Tooling Research and Application Department
Dr. Viktor P. Astakhov

Part and Feature: XXXXXXXX XXXXXXXX

Problem: Three prematurely failed tools due to oversize.

Figure 1. Three prematurely failed tools

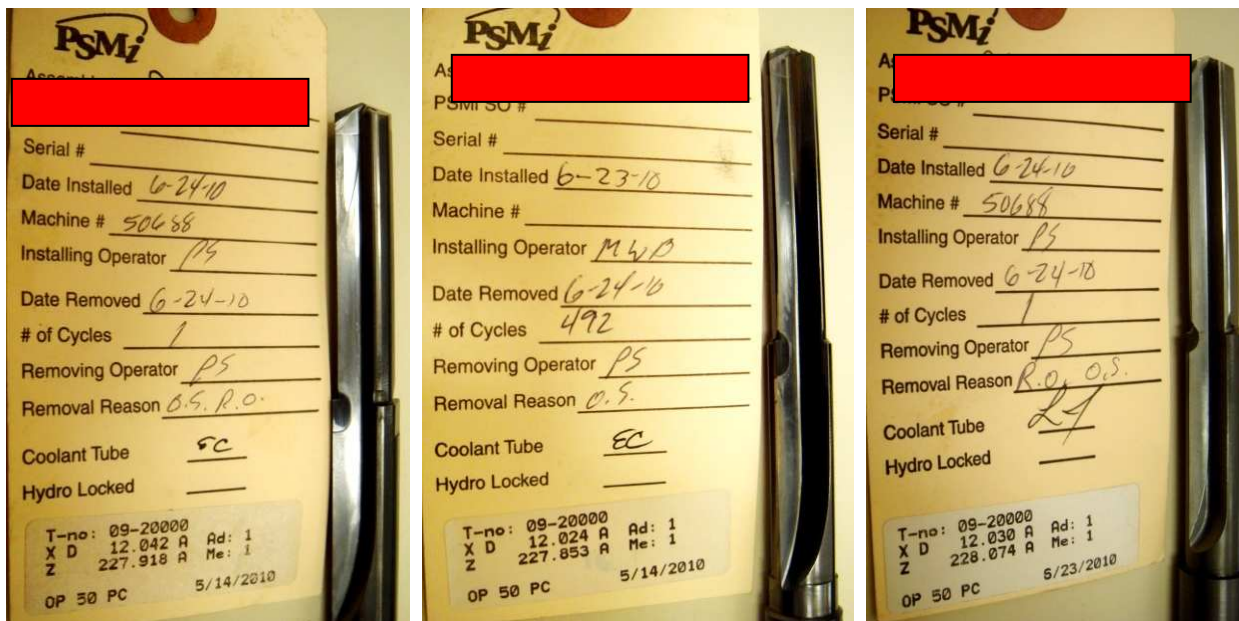
Figure 1 shown three prematurely failed tools. As can be seen, the first tool made 1 cycle, the second – 472, and the third – 1 cycle of 20,000 cycles set as tool life. Another observation can be gained from Fig. 1 – the third tool is not the same as the first two. The first two are veined drills standard for XXXXXXXX while the third tool is a PCD-tipped g-style drill. Farther investigation showed that this third drill was originally manufactured by XXXXXXXX and then re-tipped (repaired) by XXXXXXXX

Figure 2. Asymmetrical grind of the first drill

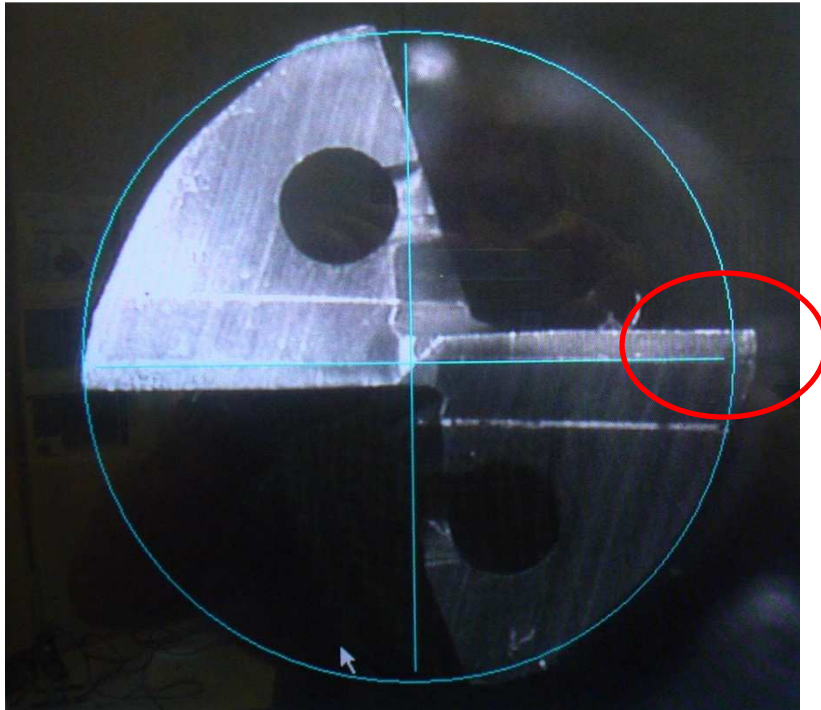
Microscopic analyses of these three tool showed that the root cause of the problem is asymmetrical location of the cutting edges and supporting parts with respect to the axis of rotation. Figure 2 shows the problem for the first drill and Fig.3 shows the issue for third drill. It

1. Provide the proper tool drawing where the components of cutting tool geometry, symmetry (axial and radial runouts) of the major cutting edges, surface finish on all ground surface, coating information (composition, thickness, etc.), tool material (type, grade and make), proper dimensions including these of the chip flute and coolant holes), dimensional and shape tolerances are clearly indicated.
2. Provide the INSPECTION report with each tool where the actual values of the parameters critical to tool performance are shown.

Figure 5. Symmetrical (proper) grind of the drill from PSMi inventory

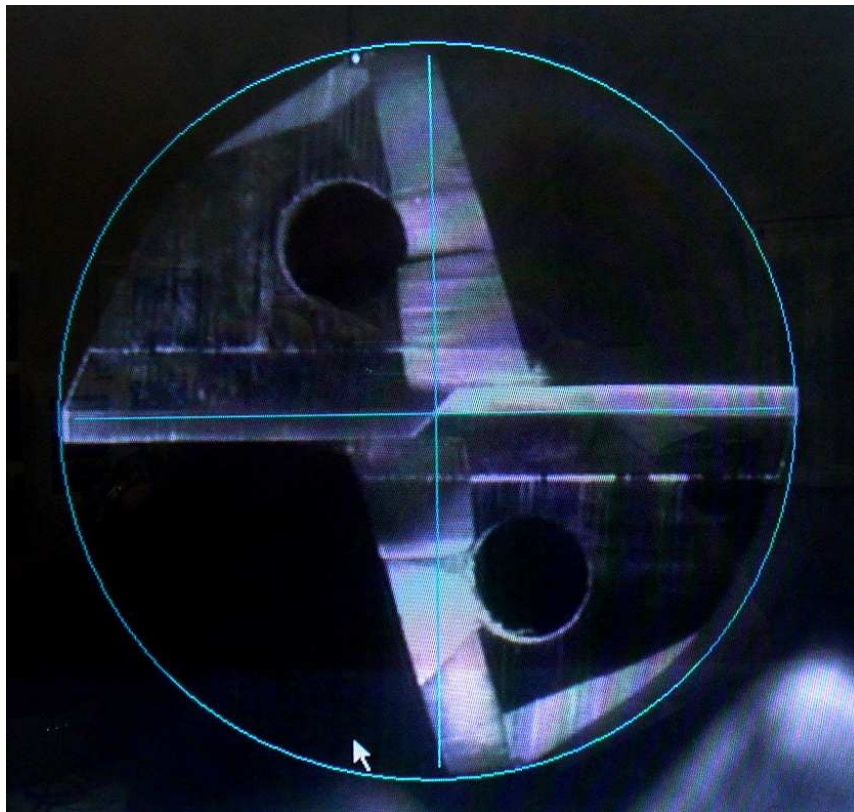
All the drills from a fresh supply were checked for symmetry to prevent the reoccurrence of the issue. Figure 4 shows one of the checked drills and Fig. 5 shows that it is reasonably symmetrical.

Figure 6. Excessively coarse grind of the flank (relief) faces of carbide part of the drill.

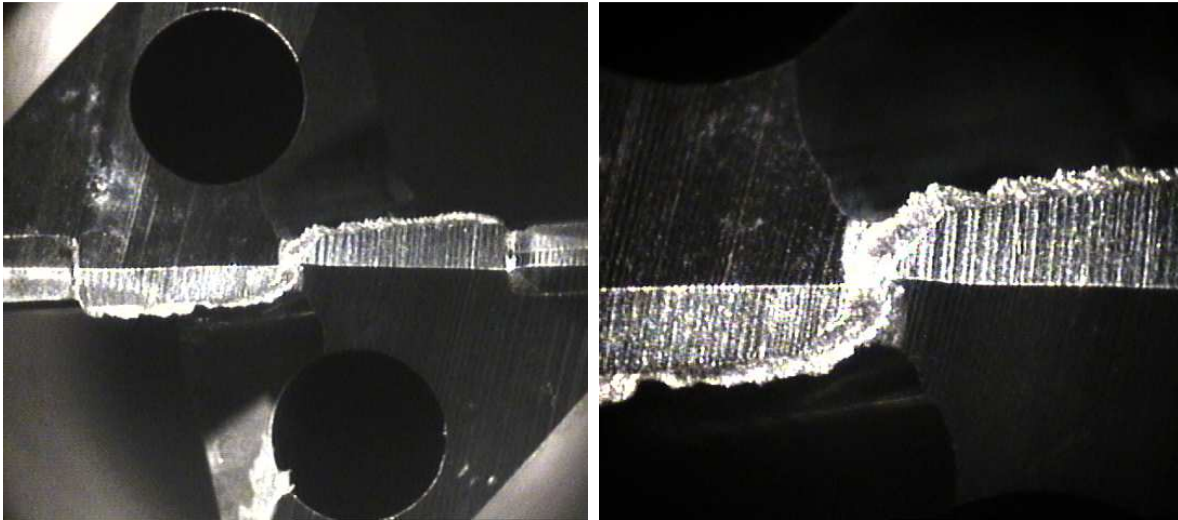
Figures 6-10 show that the third (PCD-tipped) drill was not properly manufactured. Figure 6 shows that an excessive built-up edge formed on the drill's carbide portion due to rough surface finish. Note that this drill made only ONE CYCLE. As the chisel edge of the drill is completely covered by this built-up edge, the drill lost its self-centering ability on the first cycle.

Figure 7. Excessive gap between the carbide body and a PCD insert filled by aluminum

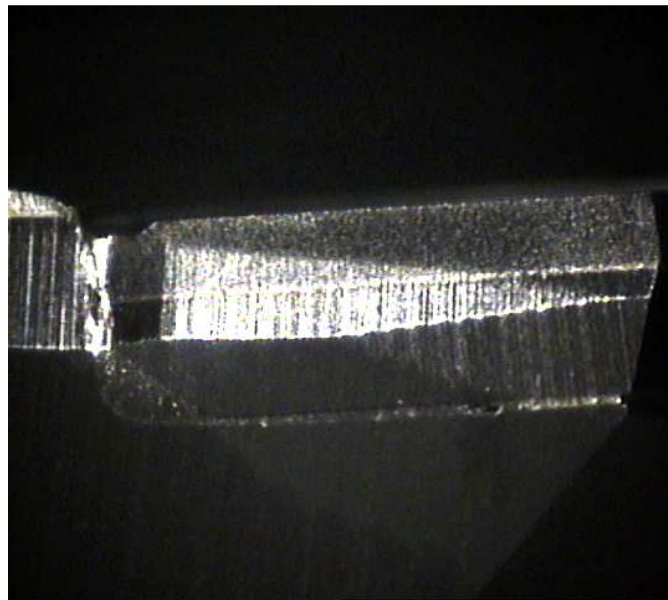
Figure 7 shows an excessive gap between the PCD insert and carbide body. On drilling, this gap is filled out by aluminum that sets drill out of the force balance, and thus cause drill wandering. Normally, there should be NO GAP and the thickness of brazing filler should not exceed 0.1mm.

Figure 8. Step on the tool rake face as the PCD insert is not aligned with the rake face of the flute

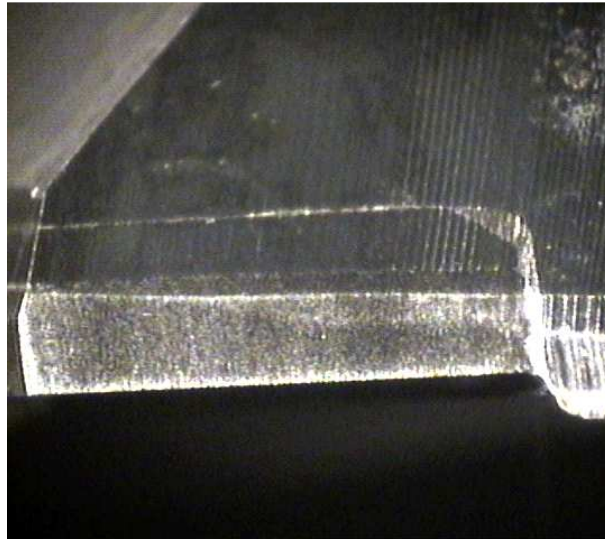
Figure 8 shows that PCD insert is not aligned with the rake face of the flute that adds additional cutting forces and causes chip accumulation.

Figure 9. Inferior brazing with voids and rubbing marks on the margin of the carbide body due to lack of backtaper and body clearance (the first PCD insert)

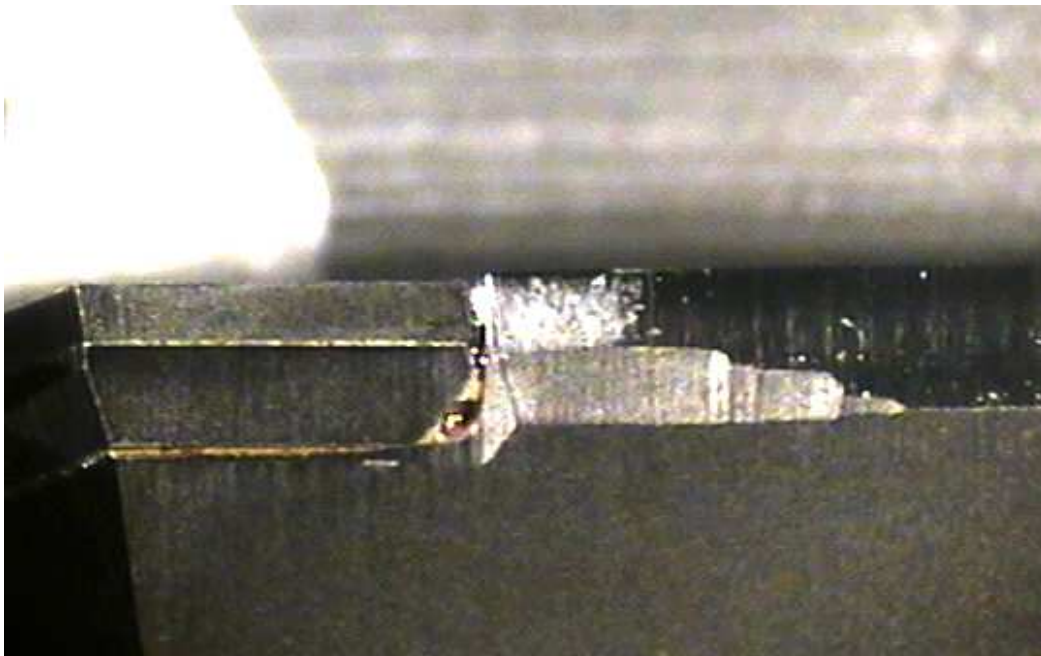
Figures 9 and 10 show inferior brazing of the PCD inserts into the carbide body with voids and gaps. The lack of backtaper and body clearance caused rubbing of the body margins that ruined the surface finish of the machined holes.

Figure 11. Aluminum built-up edge on the supporting pad due to drill's asymmetry

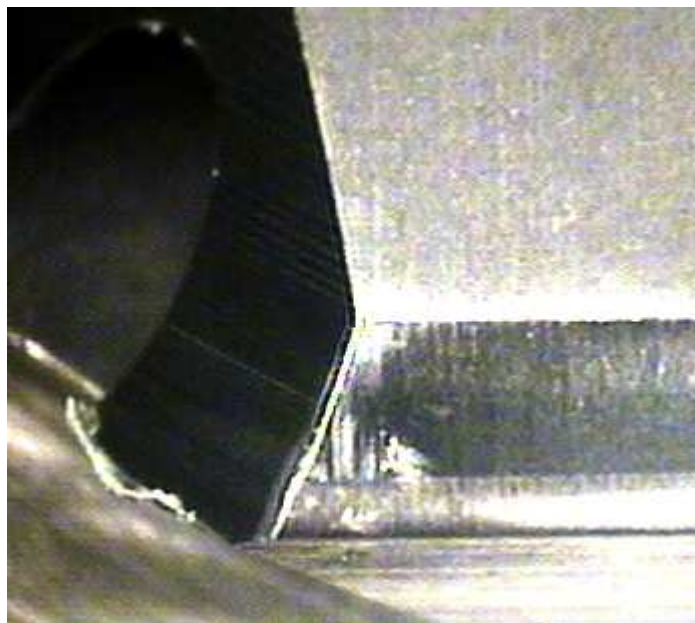
Figure 11 shows aluminum deposit or built-up edge on the supporting pad due to drill's asymmetry as drill was wandering on the hole being drilled due to asymmetry and violation of its force balance.
